LA JOLLA SHORES PERMIT REVIEW COMMITTEE MINUTES
LA JOLLA COMMUNITY PLANNING ASSOCIATION

Tuesday, January 21st, 2020 @ 4:00 p.m.

b. K-4 RESIDENCE SDP (1st Review)

Note: The following comments pertain to drawings dated 9-30-2019 that were presented to the La Jolla Shores Planned District Advisory Board on Dec. 10, 2019.

Aerial view of the existing out of the roadway parallel parking spaces.

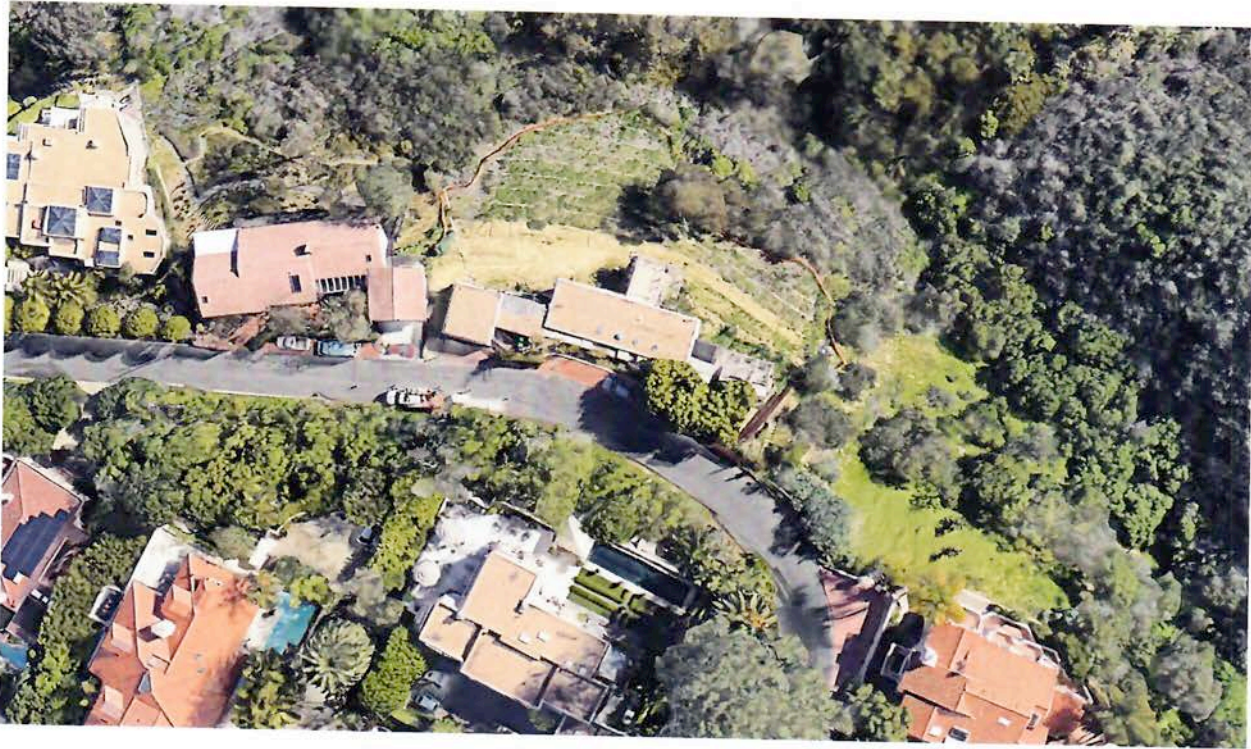
Contrary to the Parking Regulations the project fails to provide the required minimum driveway length to accommodate off-street guest parking, and eliminates the existing badly needed parallel out-of-the-roadway parking spaces on the narrow street.

LACK of REQUIRED VISIBILITY TRIANGLES / AREAS

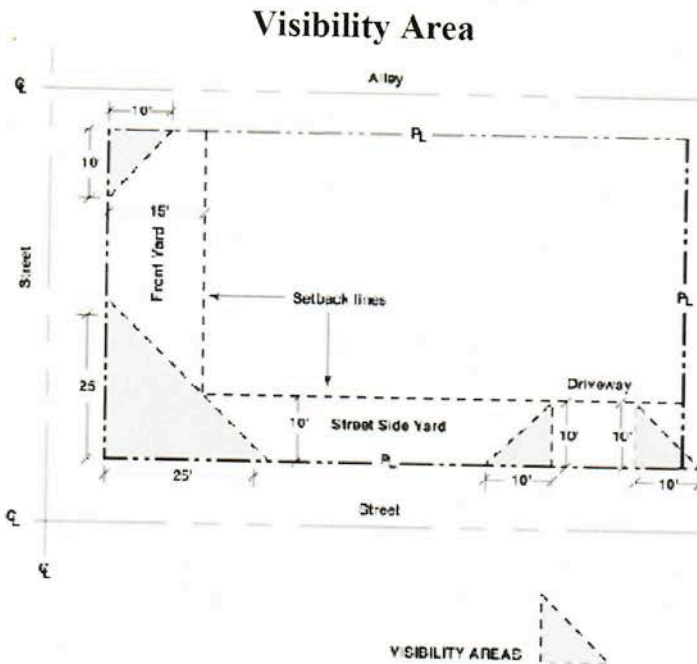
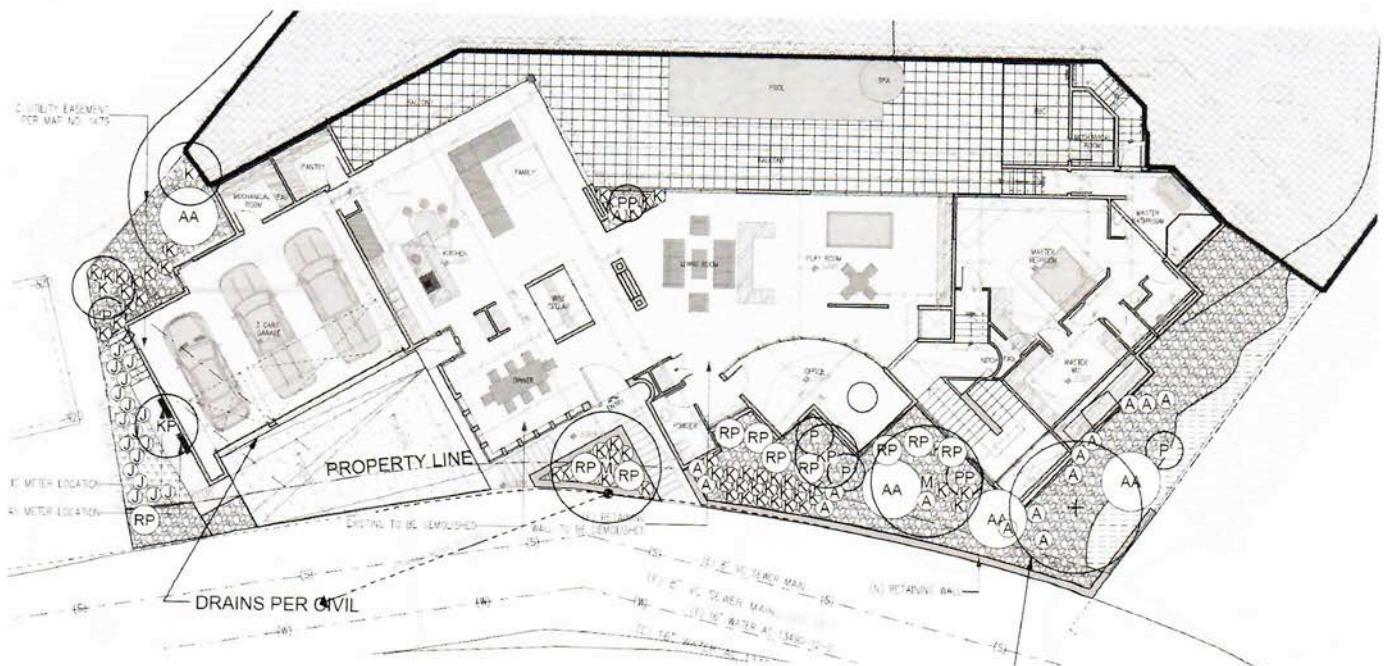
LDR-Engineering Review Comment No. 56 asks the applicant to show the driveway 'visibility triangles' (visibility areas).

A 10' x 10' clear visibility area is required where a driveway enters a street. The proposed Dining Room extends into the southern visibility area and blocks the line of sight. On the north side of the driveway, the garage is less than 10 feet from the property line and blocks the line of sight.

FRONT YARD SETBACK Not in Conformity with Those in the Vicinity

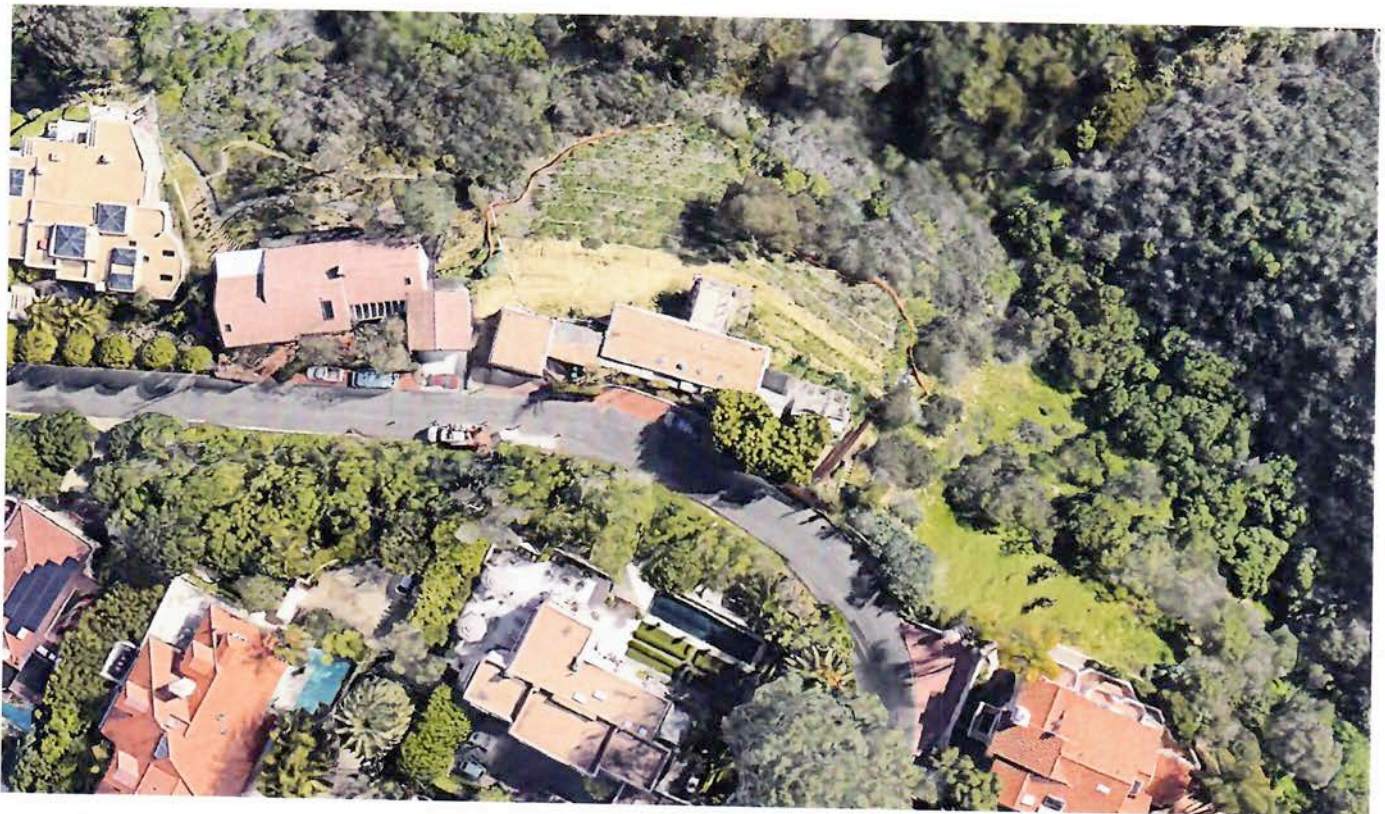
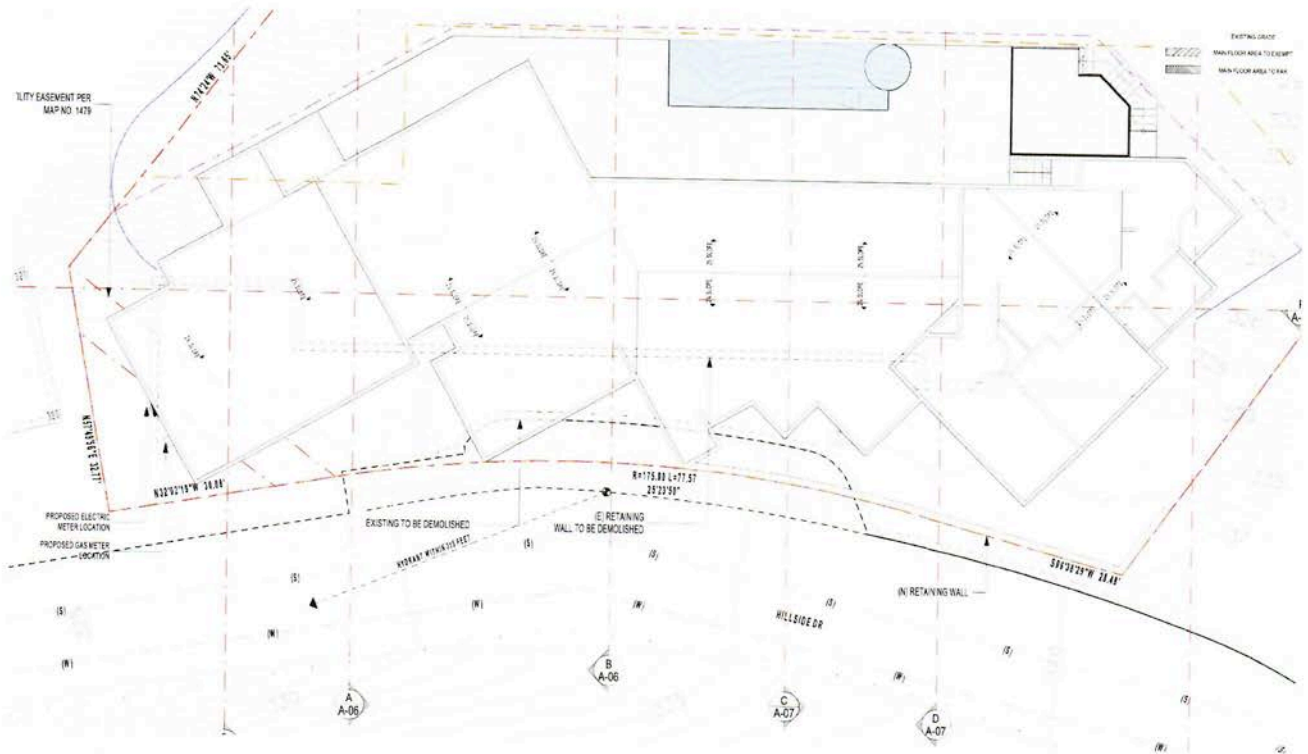
As depicted previously and below, two front corners of the proposed house actually touch the front property line. The LJSPDO says: Building and structure setbacks shall be in general conformity with those in the vicinity. None of the homes in the vicinity touch the front property line.

FRONT GARDEN RETAINING WALLS Within the Street Right-of-Way

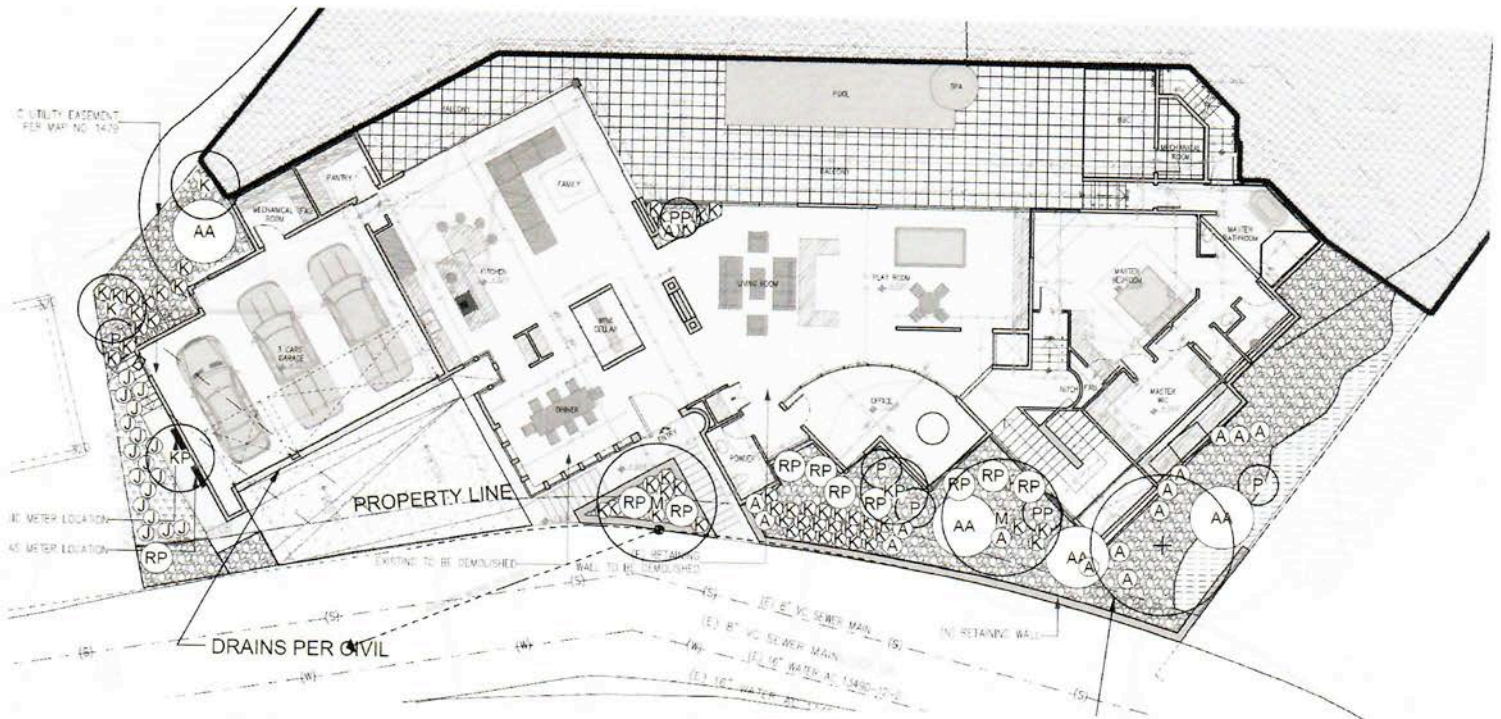
As depicted on the SITE PLAN A.01, DEMO PLAN D.01, and LANDSCAPE CONCEPT PLAN L-1, the project proposes exterior entry stairs and retaining walls within the public right-of-way to create a front yard sunken garden at the Main Floor Level.

LDR-Engineering Comment No. 44 directs the applicant to remove the retaining walls and entry stairs from the ROW.

The lack of any setback of the retaining wall structures is not in conformity with the setbacks in the vicinity, and eliminates the existing out-of-the-roadway parallel parking.

EXCESSIVE RETAINING WALL HEIGHT Disrupts the Architectural Unity of the Area

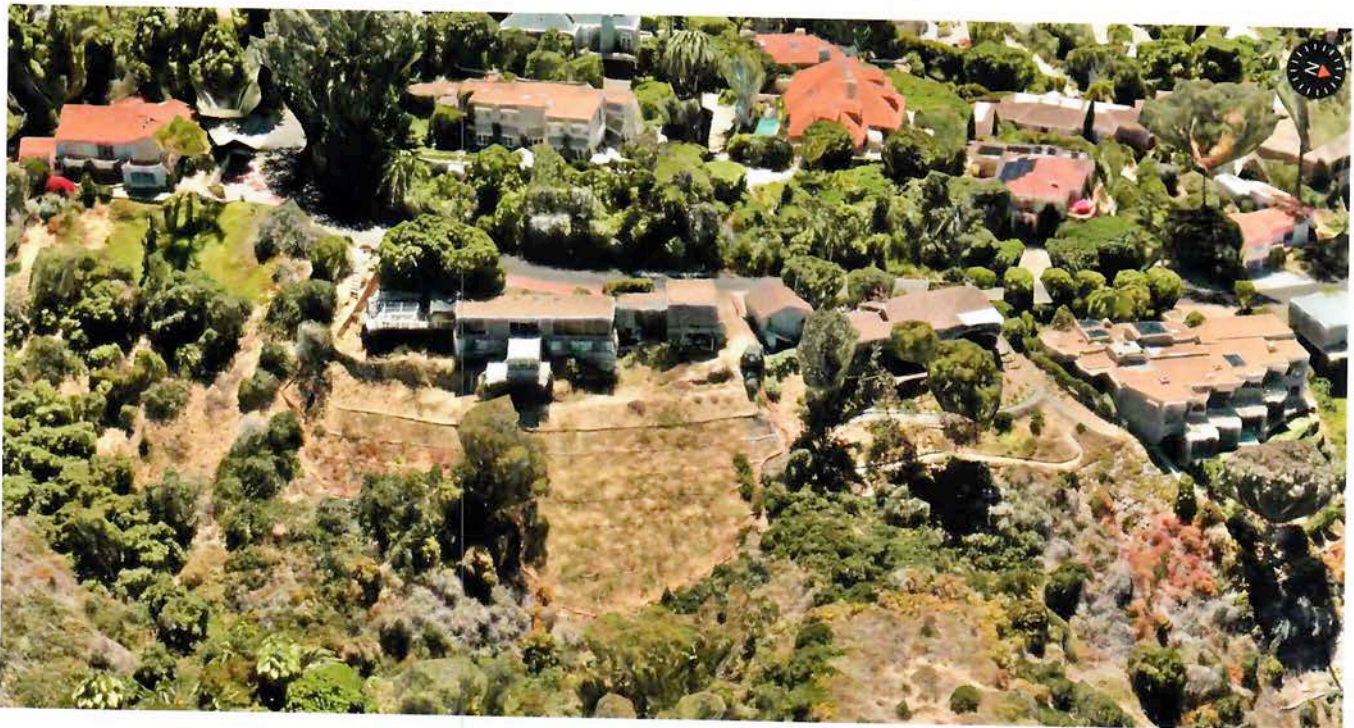
The proposed 15' high retaining walls supporting the swimming pool are not only 25 percent higher than the maximum allowed elsewhere in the city, the proposed high retaining walls projecting from the steep hillside are so different from anything in the area that they will disrupt the architectural unity of the area.
